Addendum No. 003

**Subject: Rhawnhurst Elementary School- Additions and Renovations
SDP Contracts No. B-070, B-071, B-072 and B-073 of 2019/20**

**Location: Rhawnhurst Elementary School
7809 Castor Avenue
Philadelphia, Pennsylvania 19152**

This Addendum, dated March 30, 2021 shall modify and become part of the Contract Documents for the work of this project. Any items not mentioned herein, or affected by, shall be performed strictly in accordance with the original documents.

A4.1

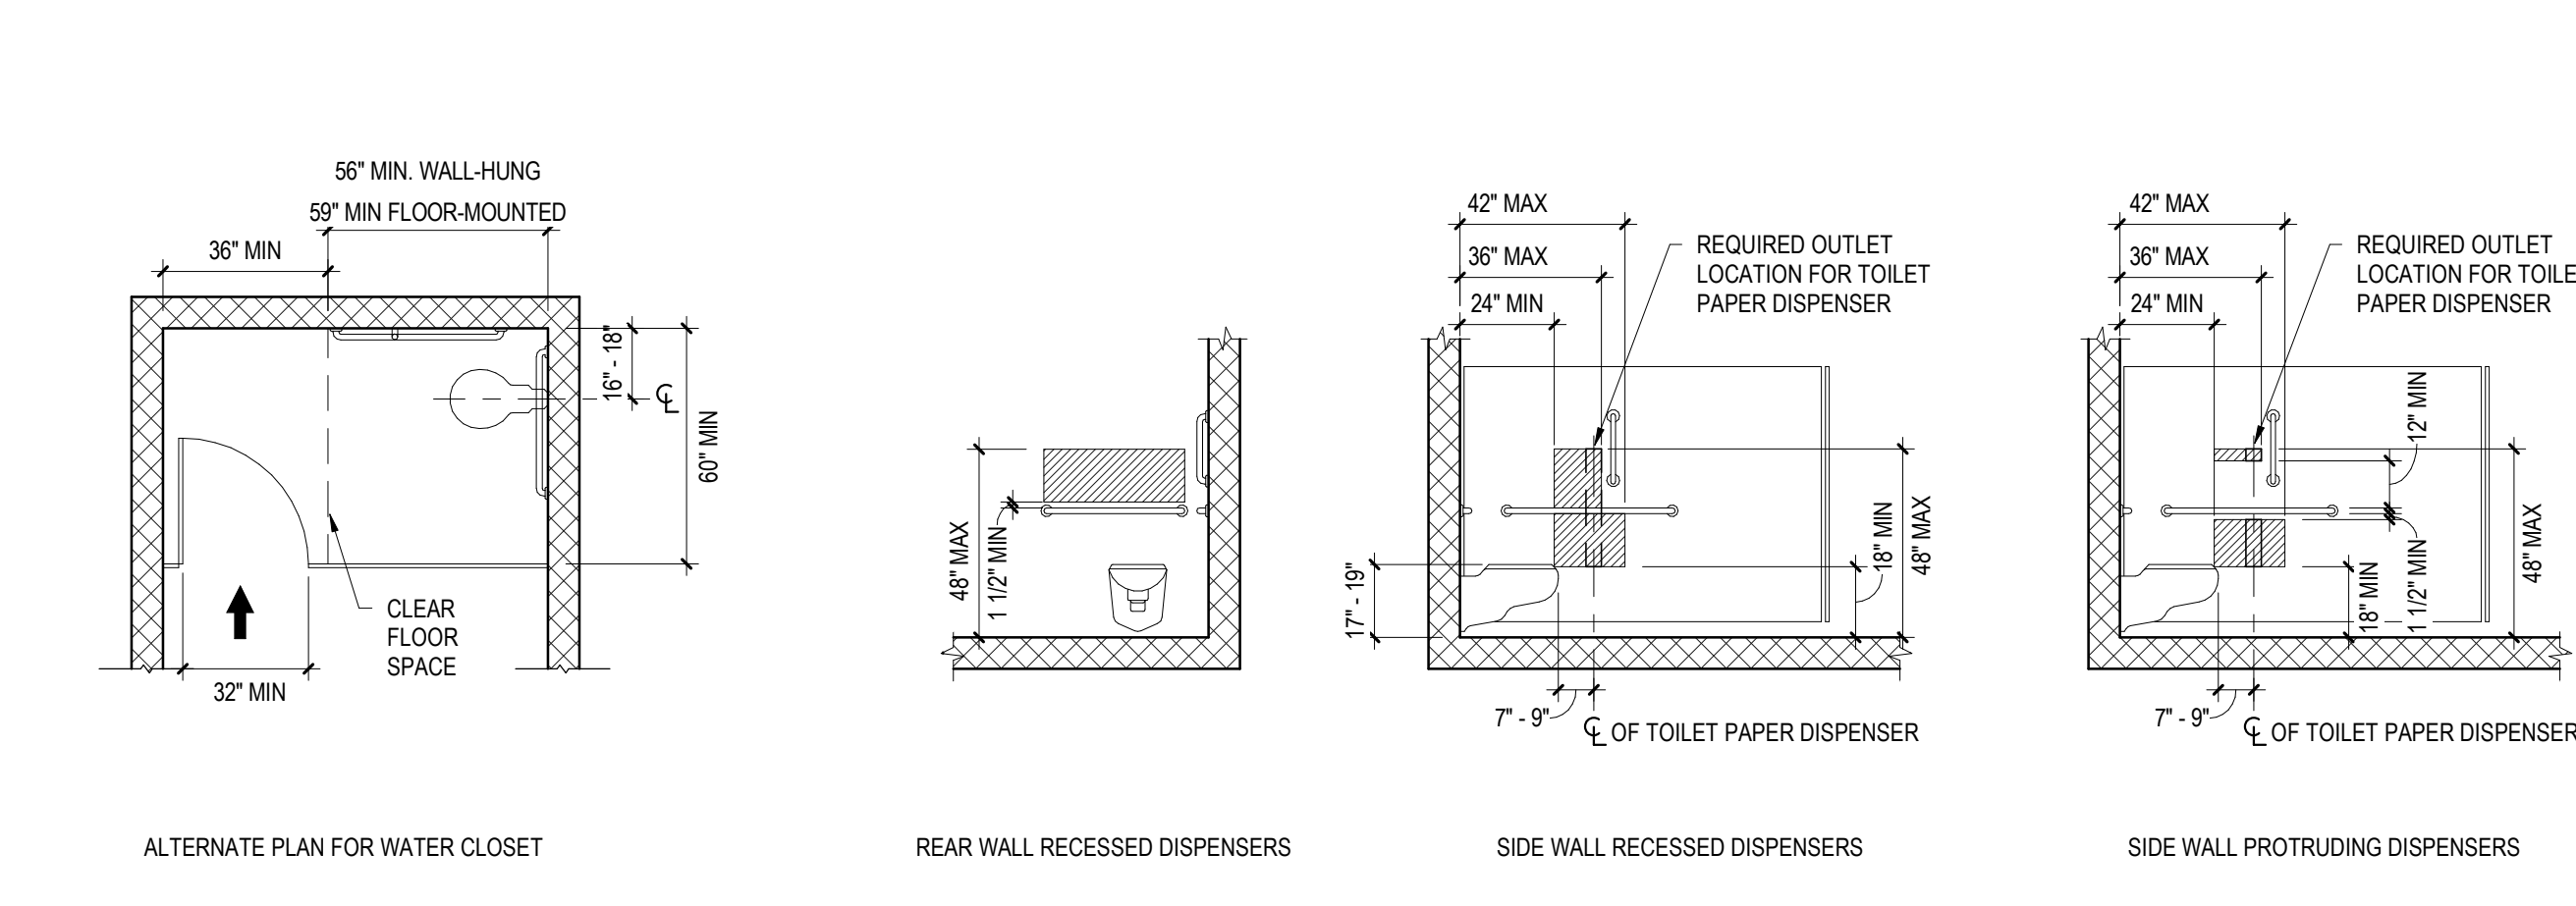
1. **REPLACE** A1.4 AND A4.1 in their entirety as part of Addendum #3. Walls are being demolished and replaced as indicated on the revised drawing to allow for plumbing demolition and replacement in the plumbing chases. These walls include B109, B110E, B115A, B116A, B117A and B118A. General contractor shall coordinate for the new installation of new plumbing and penetrations, sleeves etc. through these walls.

1 OVERALL FIRST FLOOR FINISH PLAN
17.9 1/16" = 1'-0"

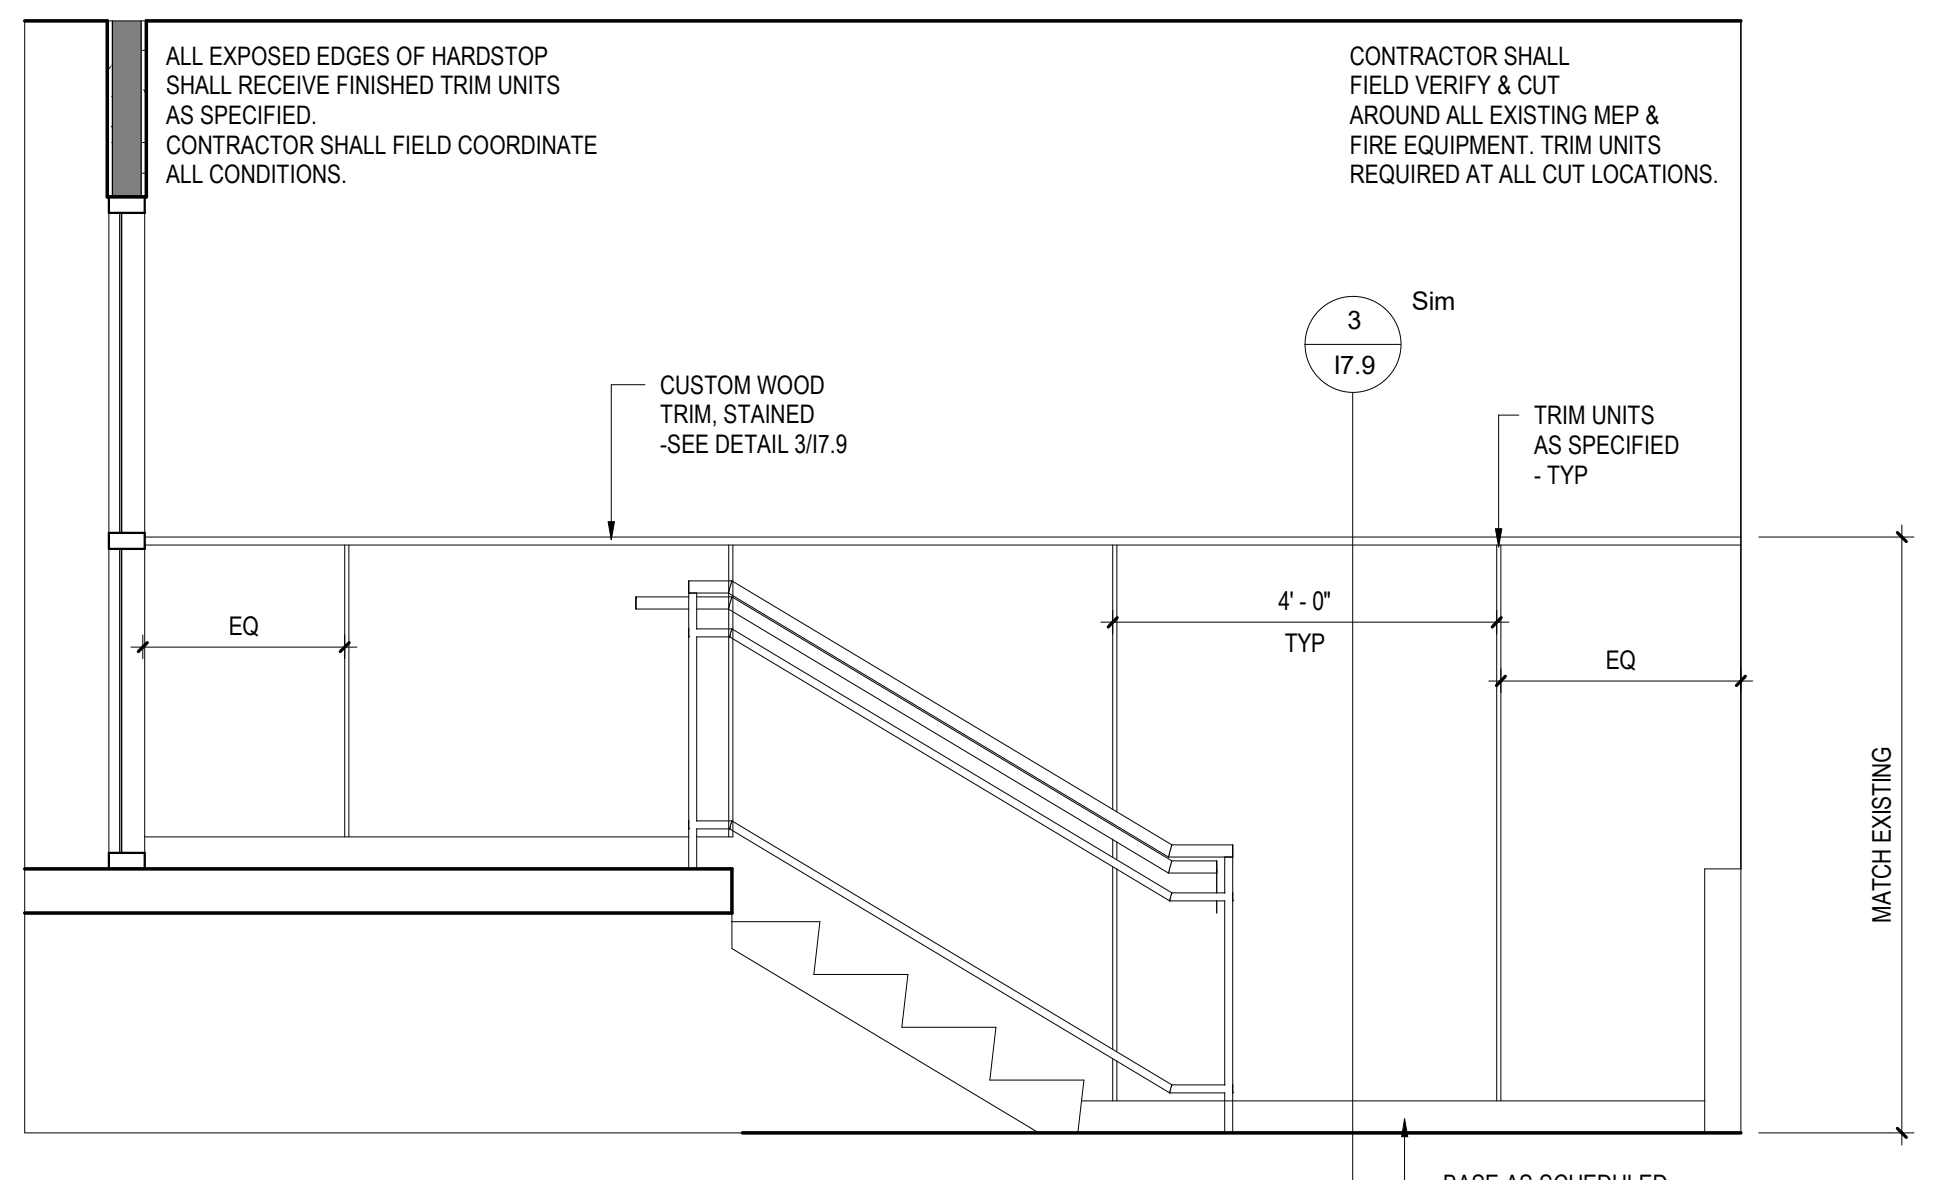
1. **ADD** notes for tile accent wall at A107, B103, C124, & C125.

1 OVERALL SECOND FLOOR FINISH PLAN
17.10 1/16" = 1'-0"

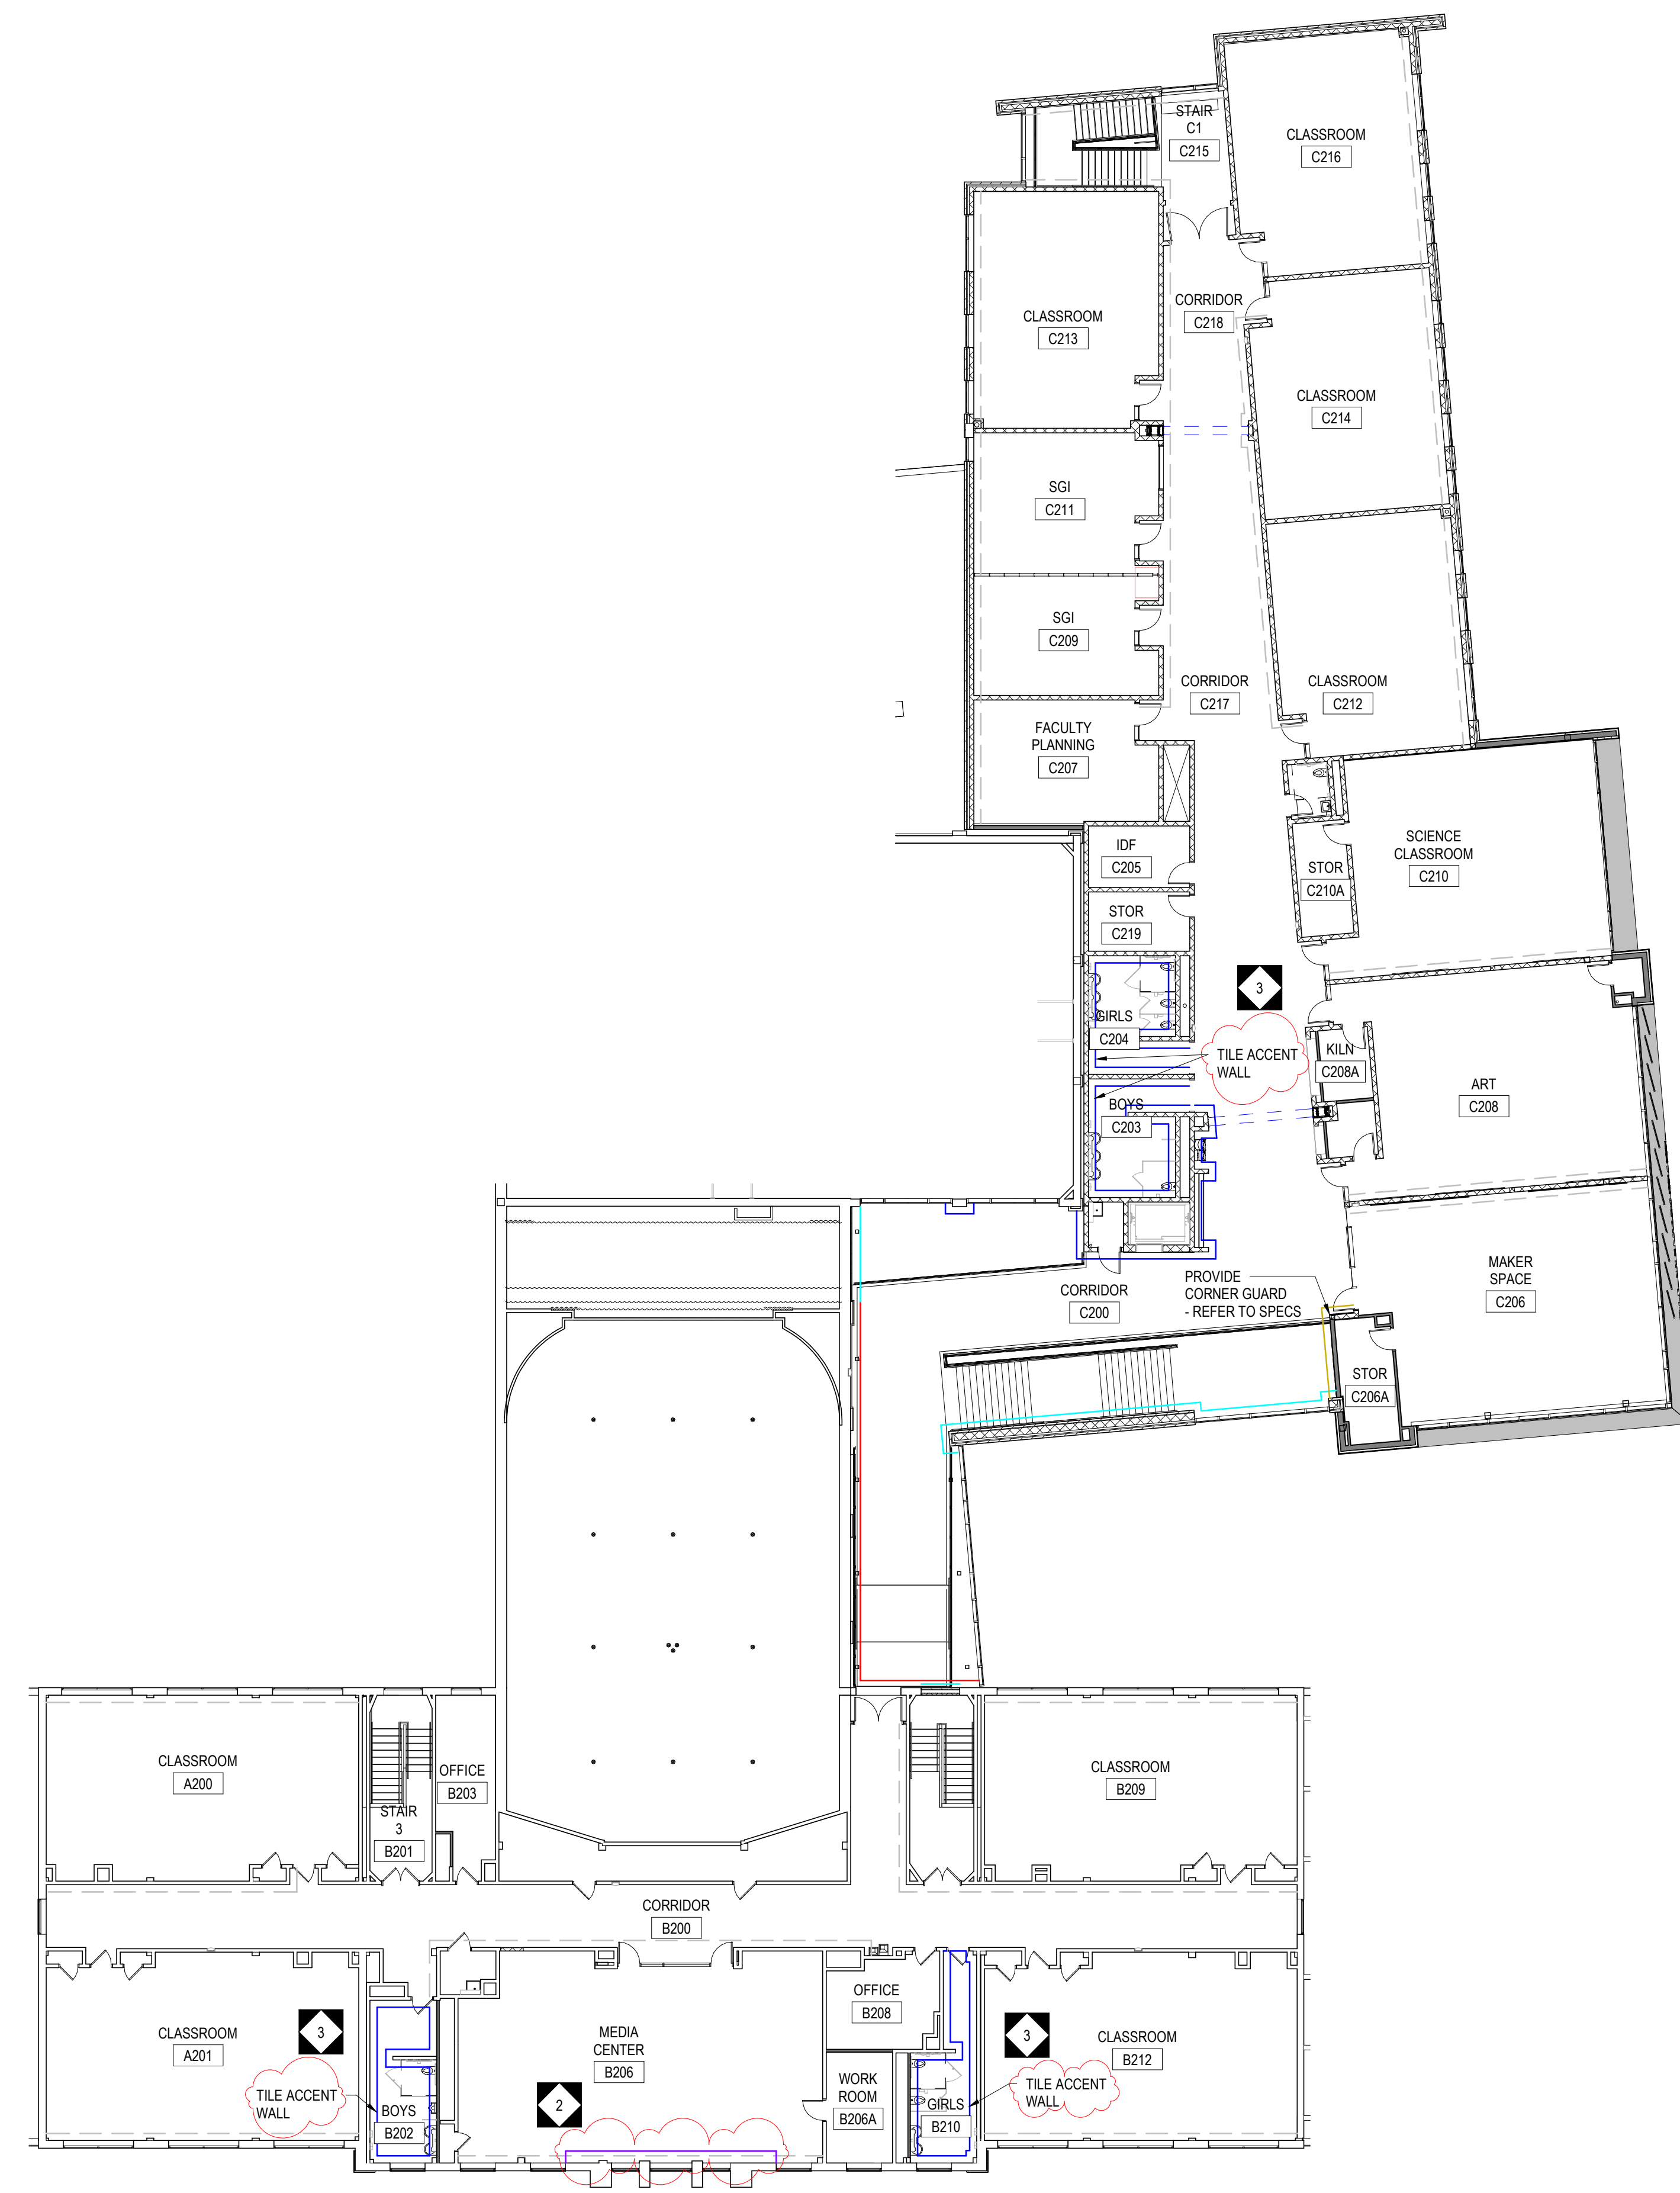
1. **ADD** notes for tile accent wall at B202, B210, C203, & C204.
